RE: Response to Comments

Rocky Mountain Railpark Roadways – Infrastructure Site Plan – Fifth Review

Application Number: DA-2329-00

SHEET: 9 OF 31

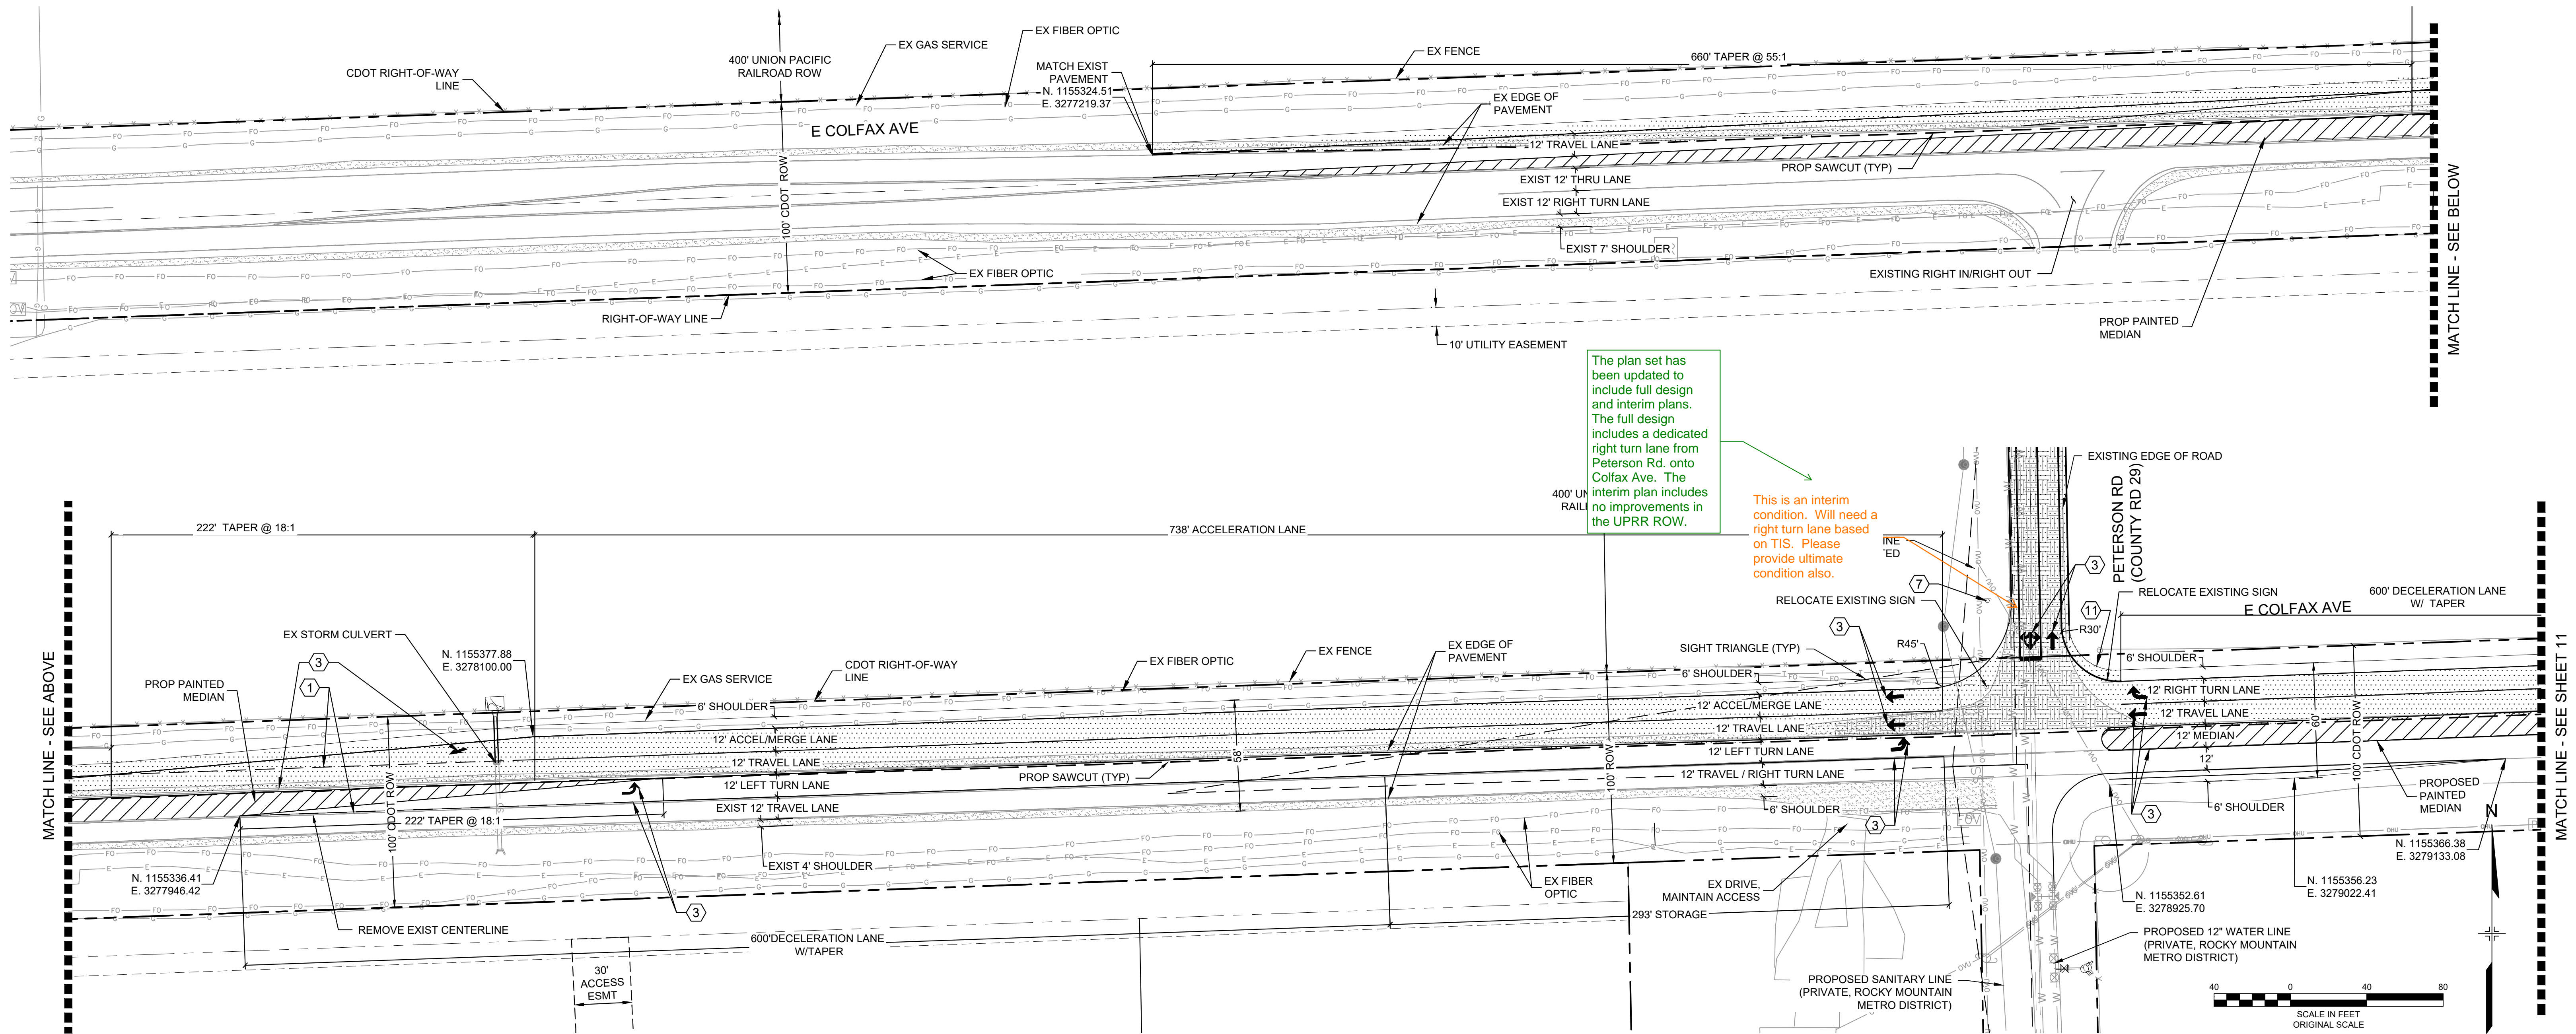
This intersection
should align better.
Eastbound and
westbound are offset
and this will cause
issues in the future.

48th Avenue ROW east of Peterson Road does not currently exist. The adjacent developer to the east will be responsible for removing the 48th Avenue offset at the time of their development. Pavement if 48th Avenue east of the Peterson Rd. centerline and North of the 48th Ave. centerline will be limited to the extents of the existing right-of-way.
